## 4. MASSING STRATEGY

## **6. AMENDMENTS**

### 6.2 Parameter Plans

## 6.1 Site boundary

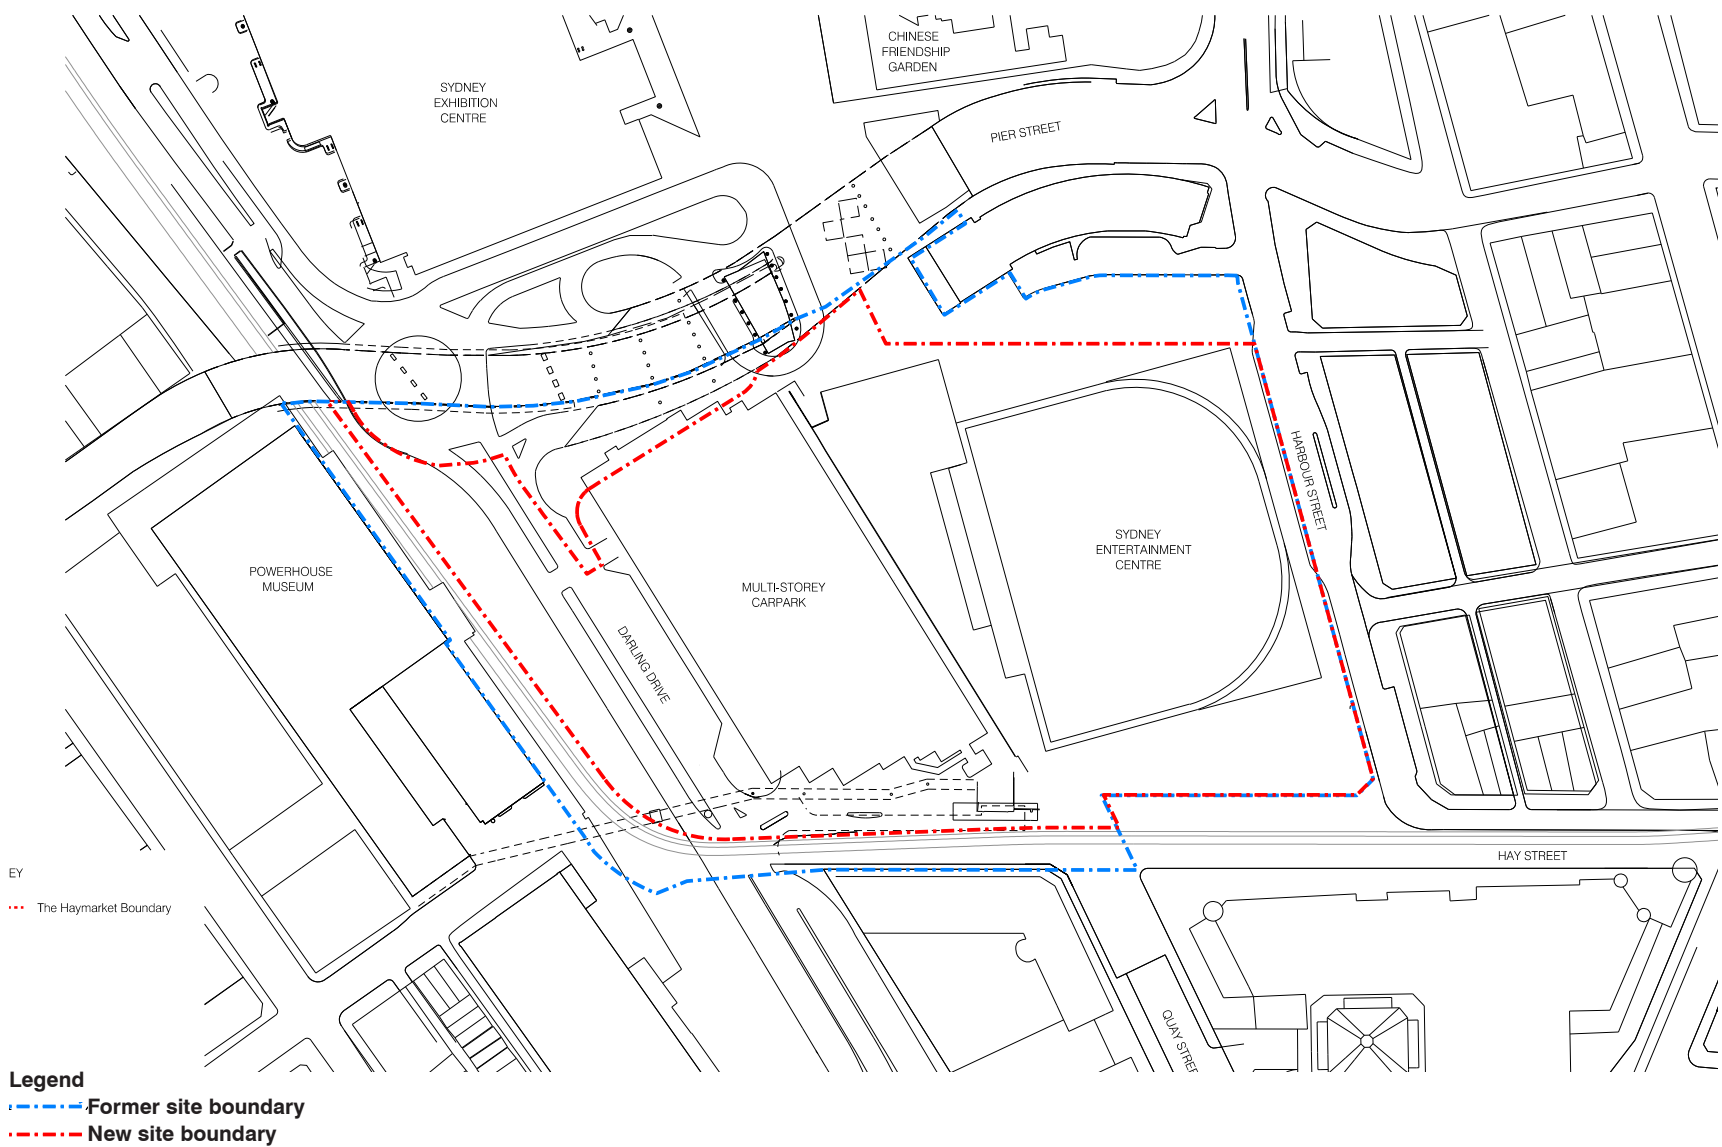
The Haymarket (PDA) site boundary line has been amended to exclude Exhibition Place which now sits within the site of the Core Facilities (PPP) defined works.

This has been a logical boundary amendment as the works involved to redesign the Darling Drive/ Pier Street junction and revised vehicle access into the site now falls within a single site boundary and Development Application.

The public car park entering and exiting the NW Plot will share this road but will not require any additional modifications to the junction geometry or lane alignment.

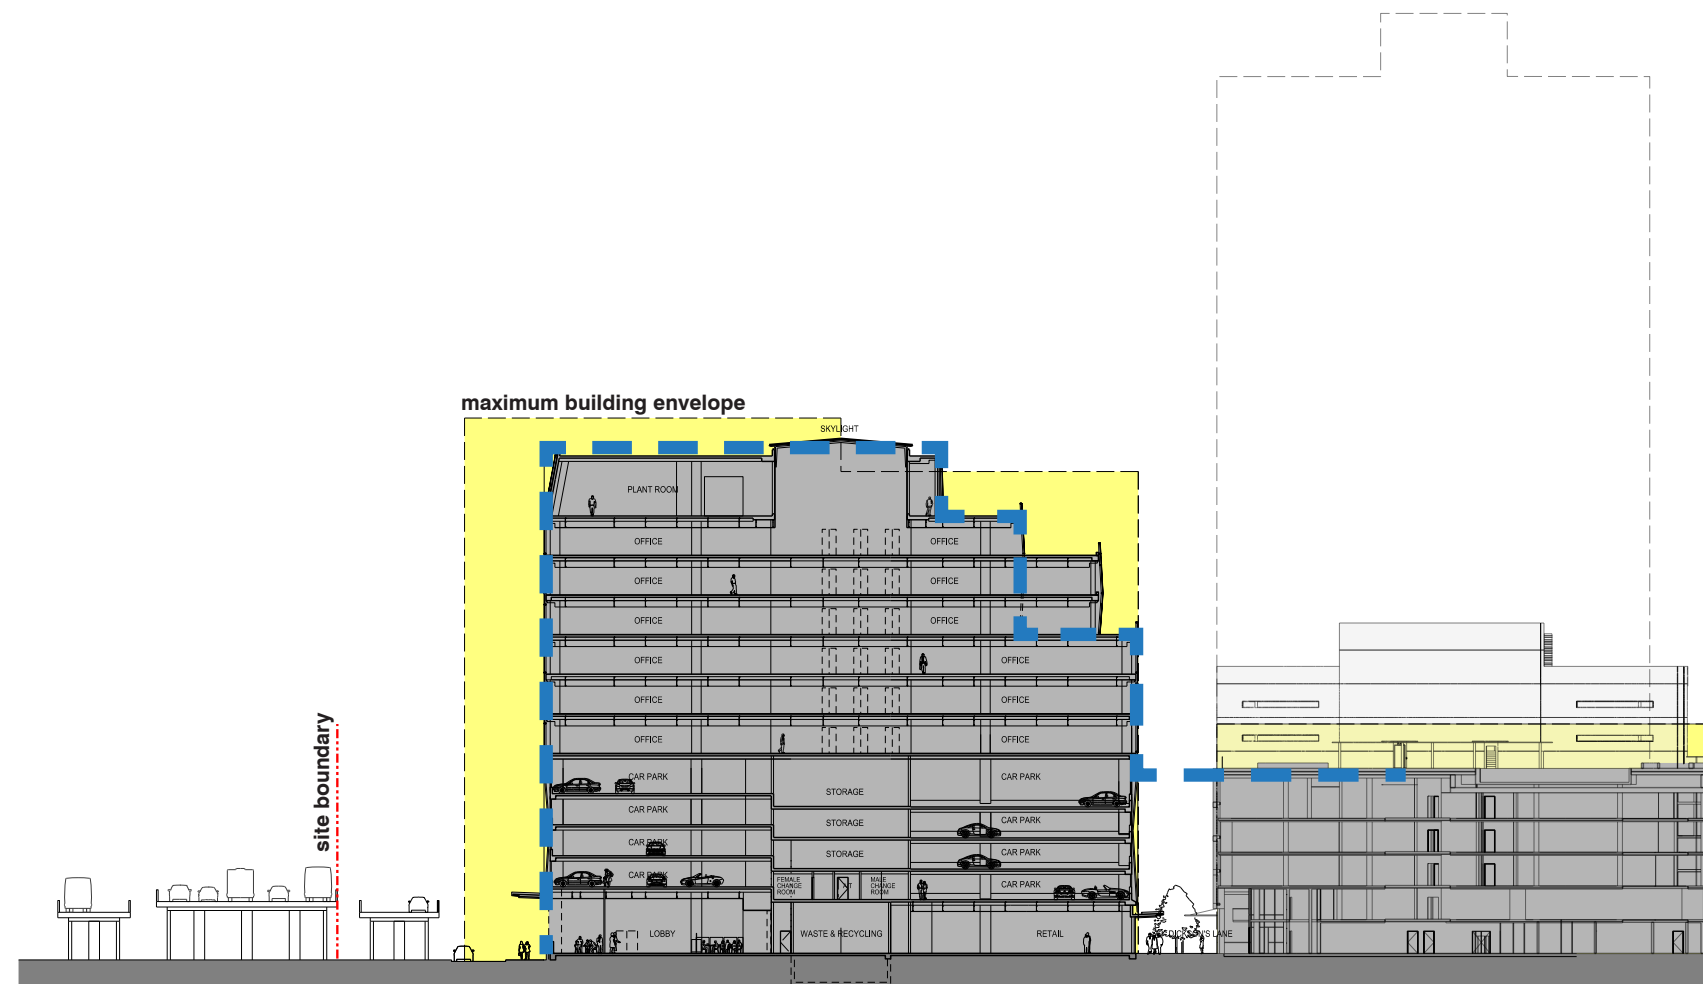
**Step location on the top of NW Plot roof has been moved south by 7.3 metres.**

The proposed massing for the NW Plot commercial buildings as submitted for SSDA 4 steps down against the SW Plot.

This is to transition the built form scale from Pier Street to Haymarket Square, reduce the overshadowing impact onto the SW Plot podium landscape and minimise proximity and overlooking issues between the SW1 tower and the commercial office space.

As a result of this terracing additional space is required to accommodate a rooftop plant enclosure.

This enclosure will be set back from the Darling Drive and Boulevard elevations to minimise any visual impacts.

**NW Plot north elevation has been amended to follow the new site boundary and not the Pier Street alignment.**

The Haymarket site boundary has been revised along its northern edge.

The Illustrative Scheme and subsequent proposal submitted for SSDA 4 do not build out to the former Parameter Plan northern boundary.

Instead the main entrance lobby is located on Exhibition Place to provide a space-positive activation and increased surveillance along this edge of The Haymarket

The setback envelope allows greater light penetration into the Exhibition Place increasing the amenity at entrance level and hopefully encouraging pedestrian usage and access into Tumbalong Park and Haymarket Square.
